DOCUMENT - 2024-346P

**Construction of the Dockstader Peel Region Paramedic Services
Reporting Station**

ADDENDUM 3

Exterior Shade Structures 3D Diagram
 A054

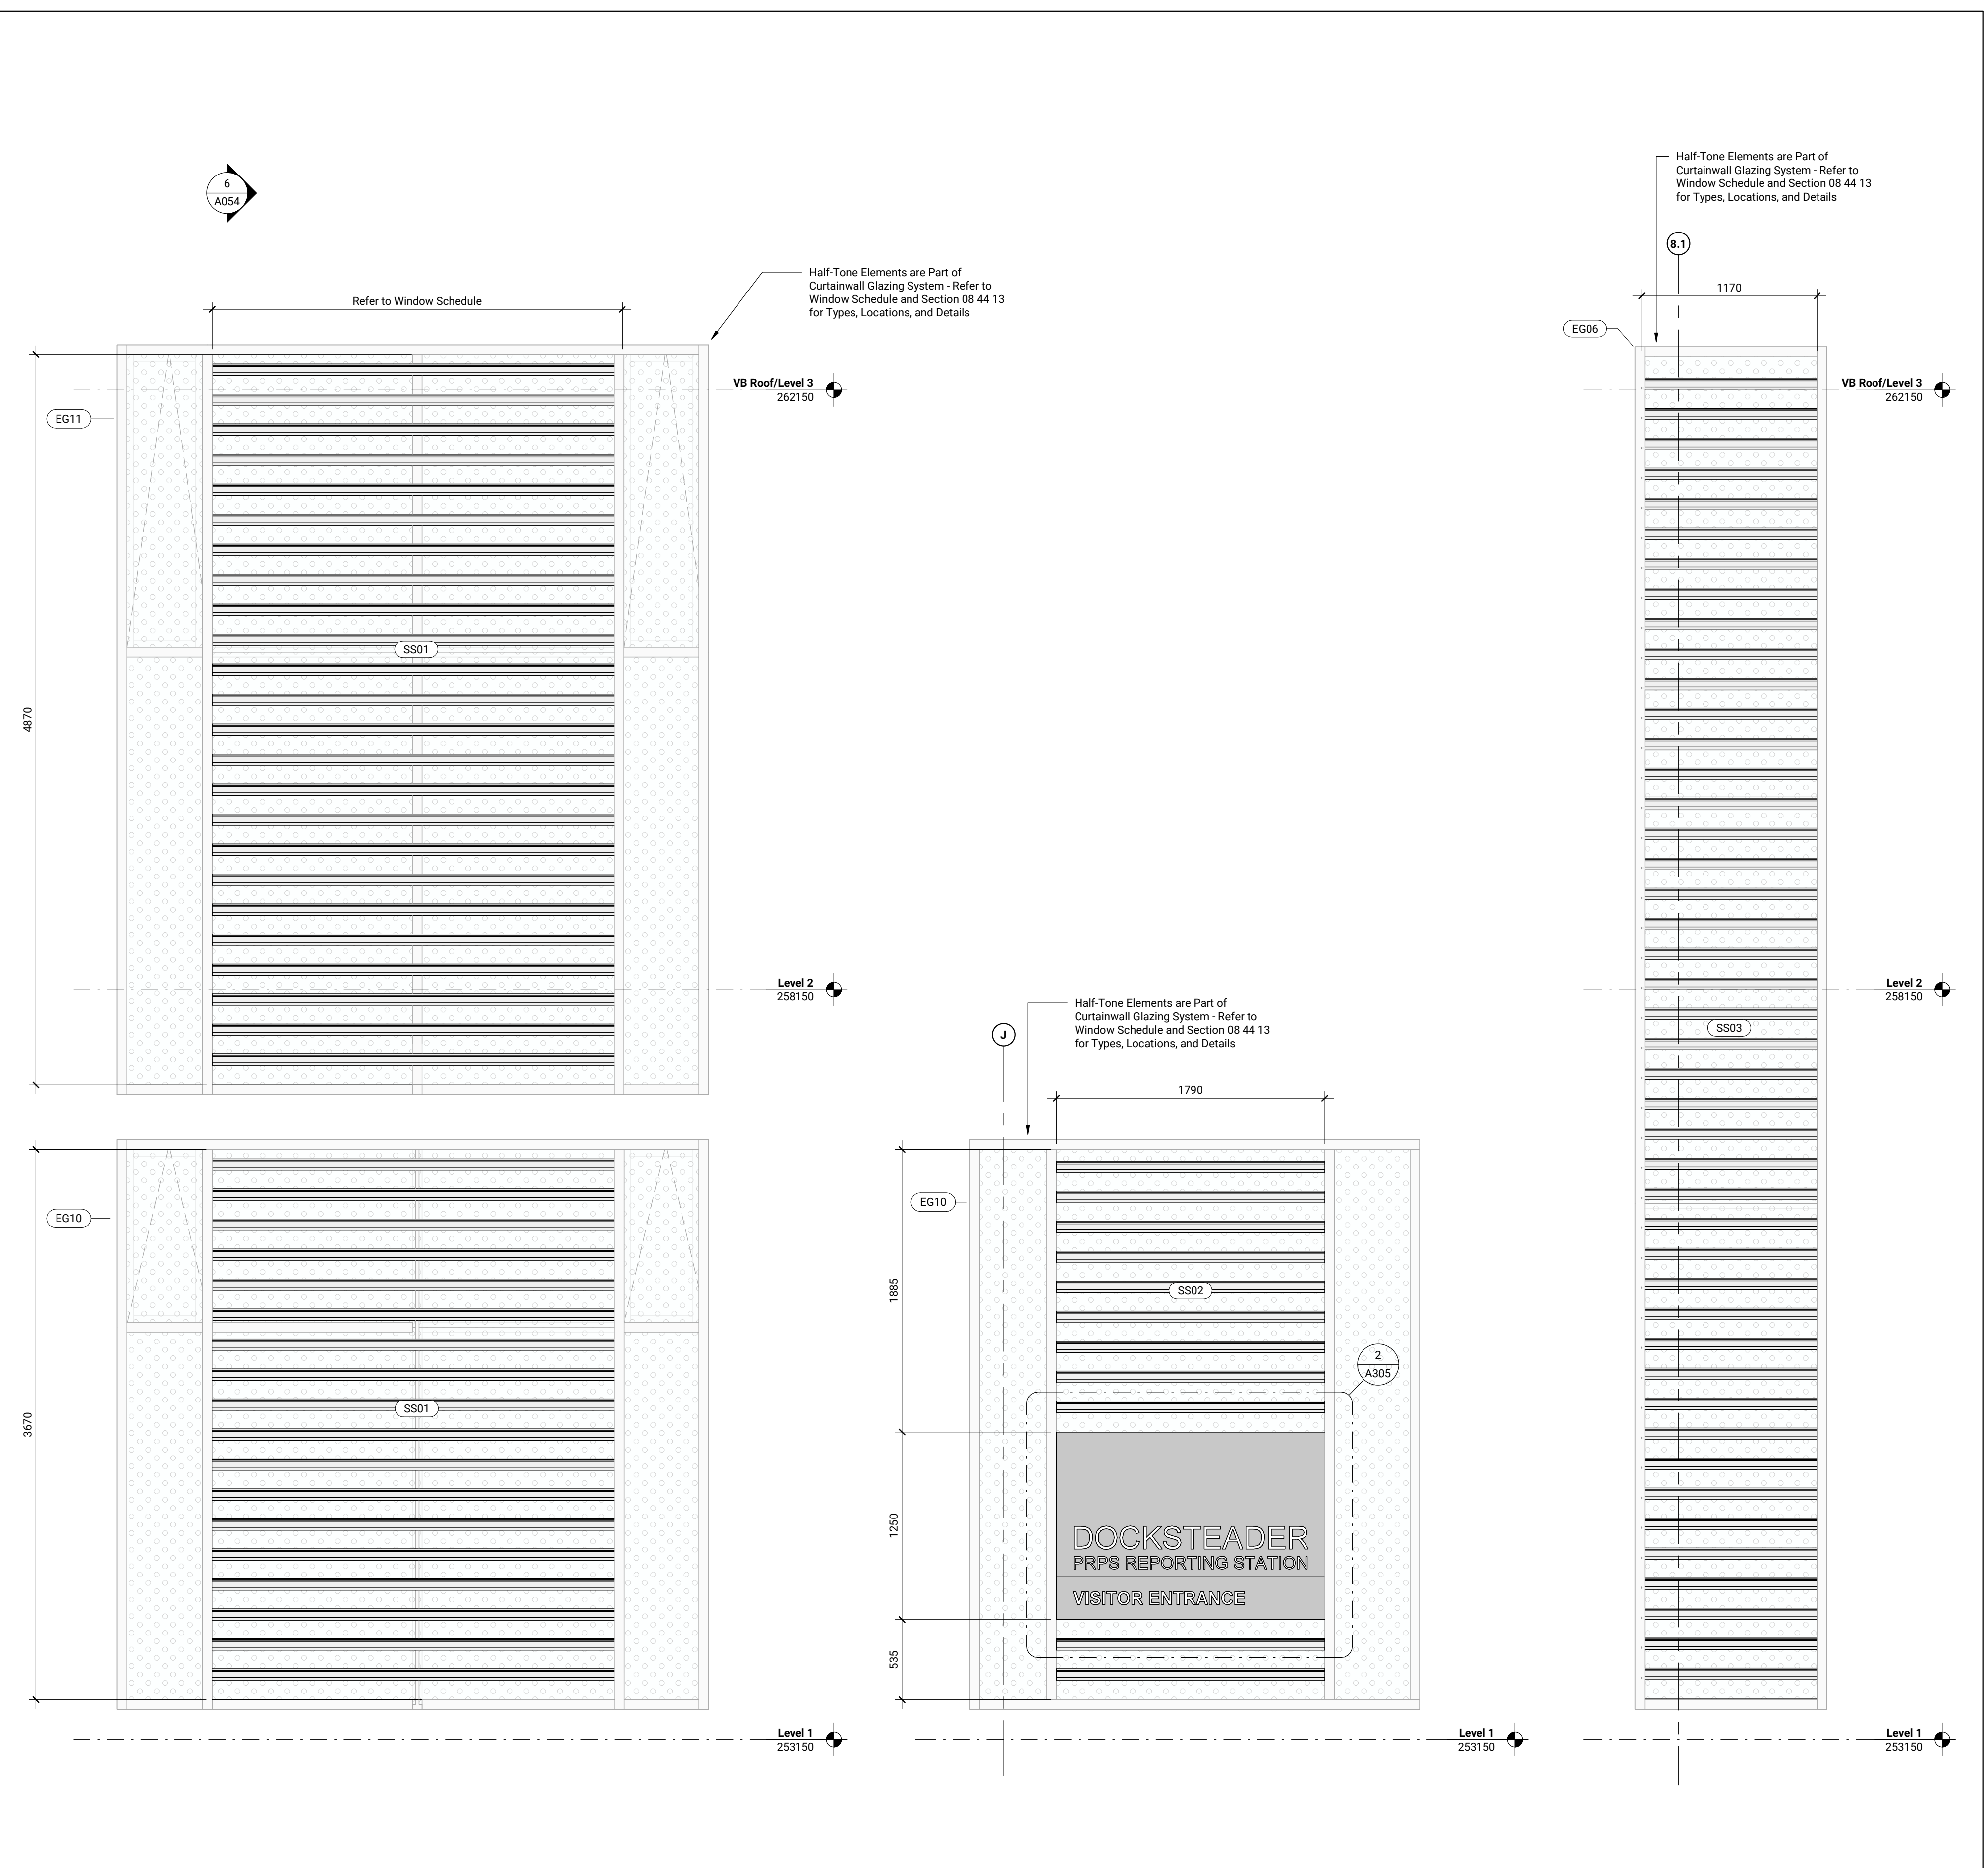
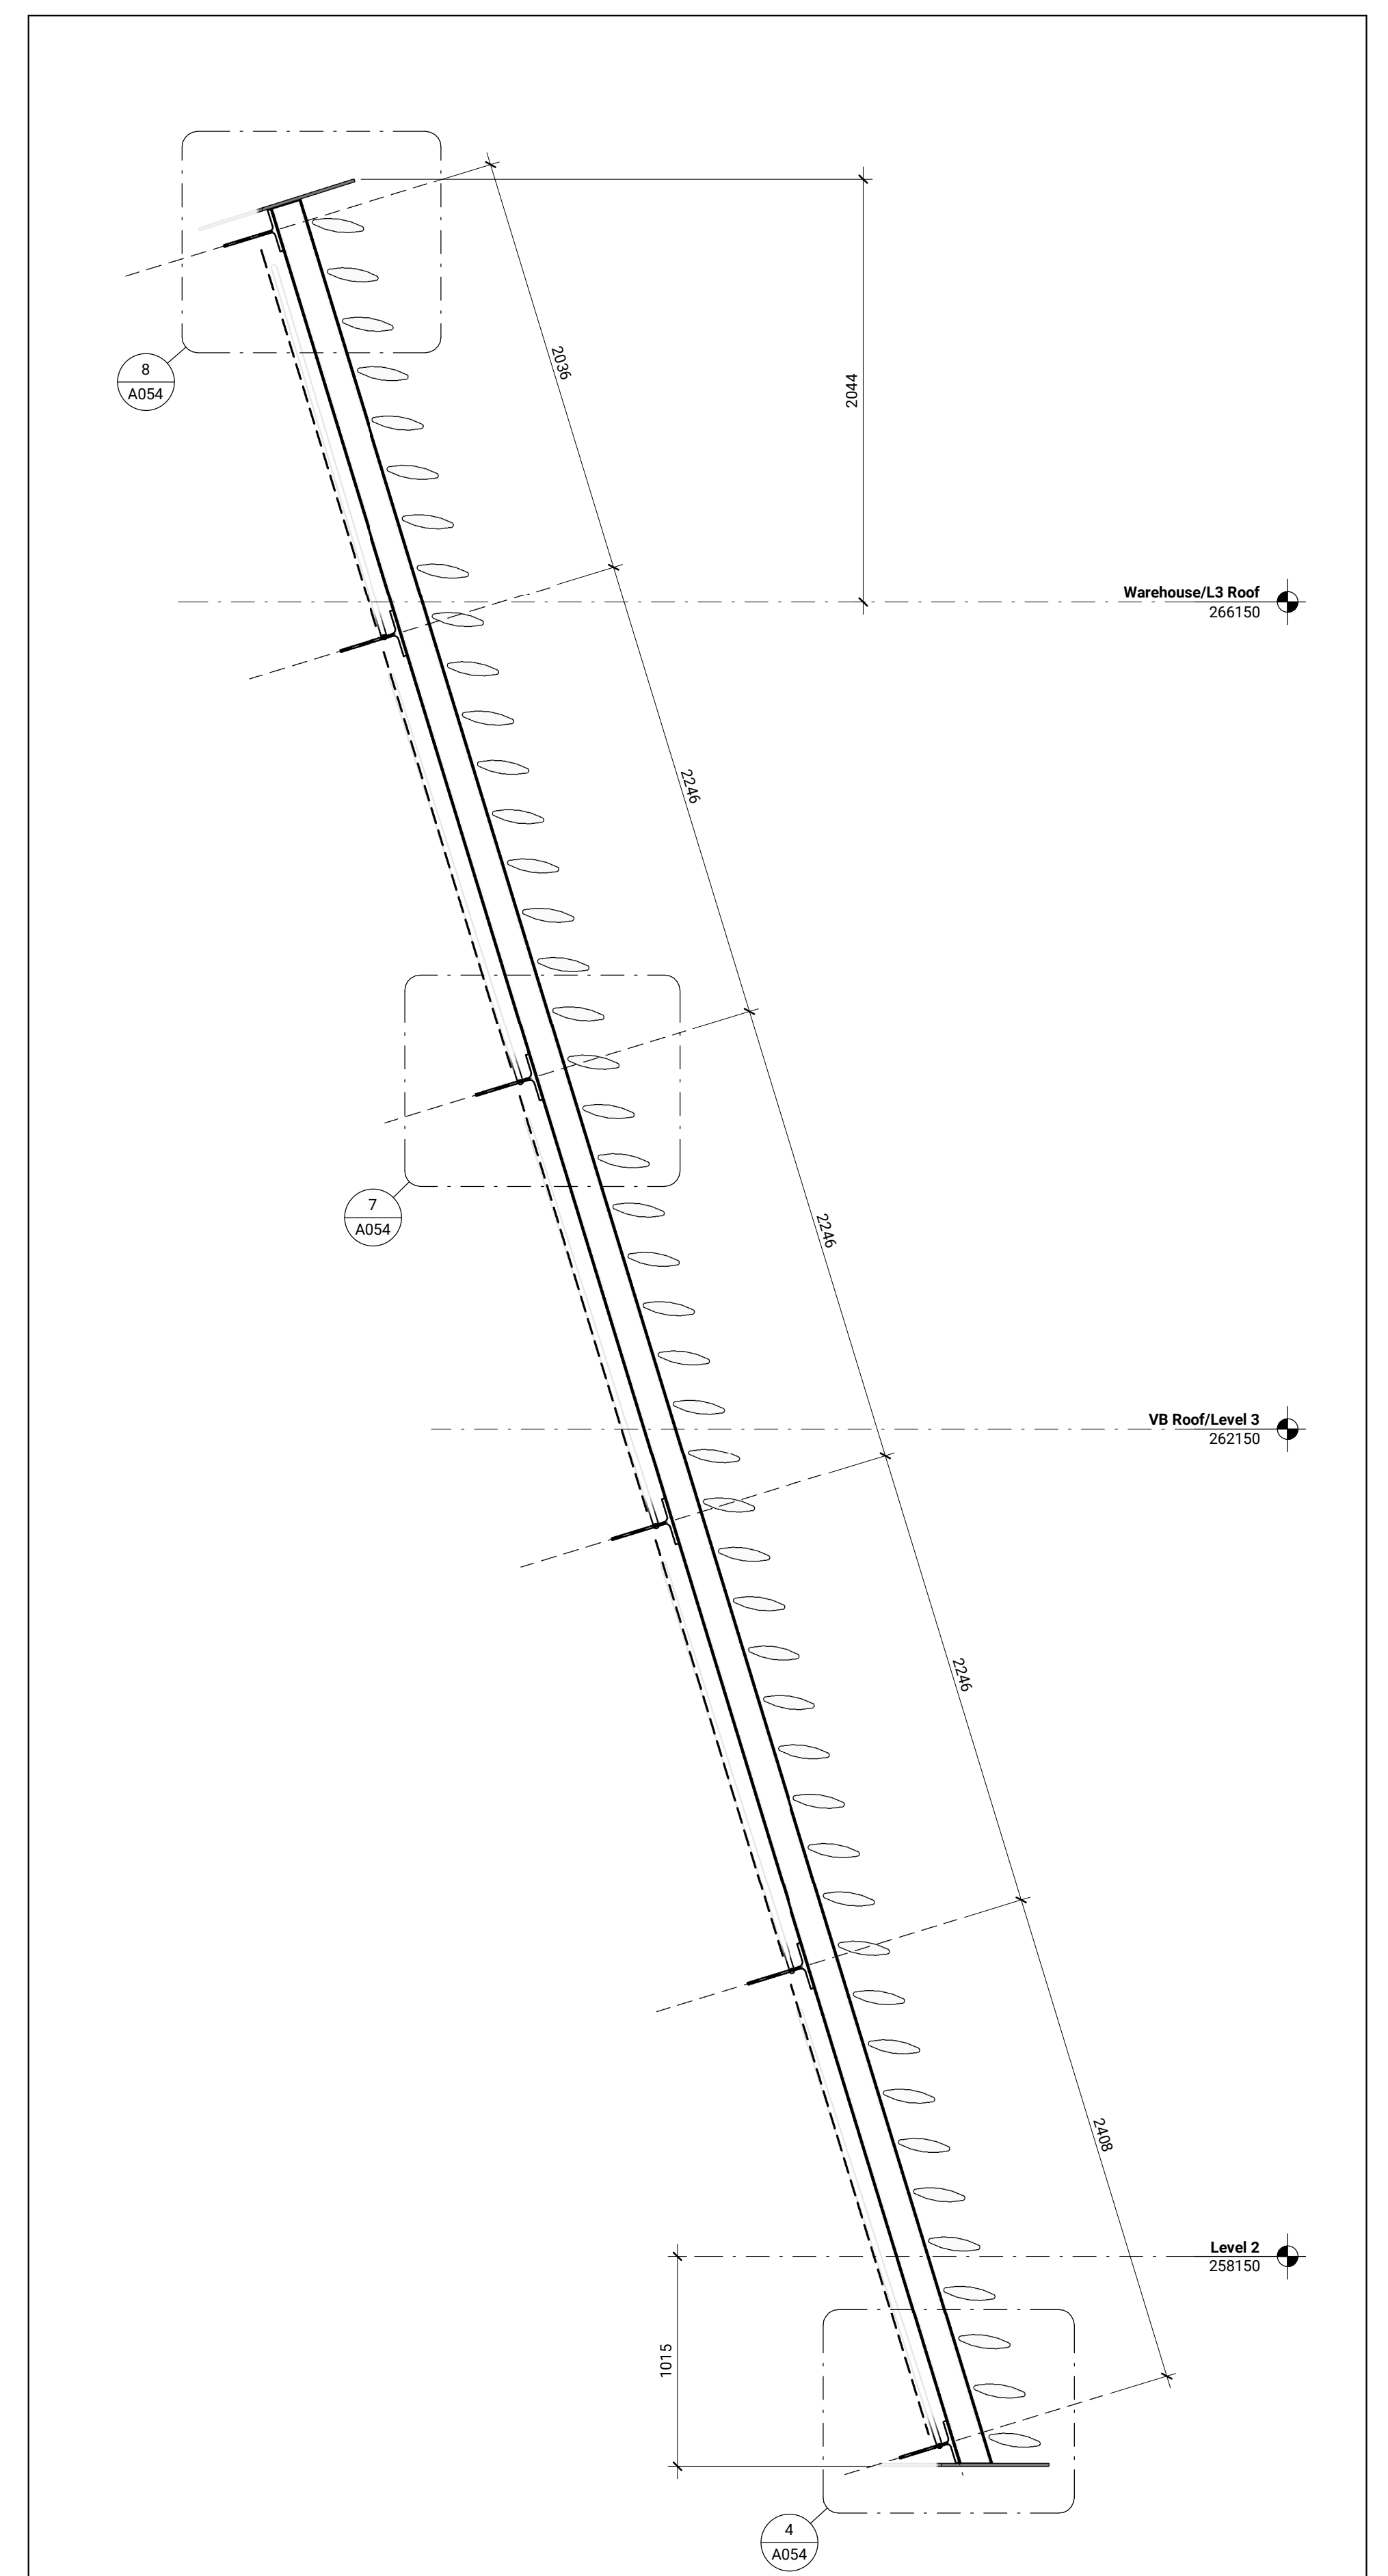
Drawing 4/A054 refers to structural drawing for framing detail of SS04 solar screen wall, but the structural drawings not shown these details. please advise.

Please refer to revised detail 4 on drawing A054 issued as part of Tender Addendum No.3. Note on 4/A054 revised for clarity to "Refer to Structural for Types and Sizing." Framing details to be coordinated through shop drawings after tender award.
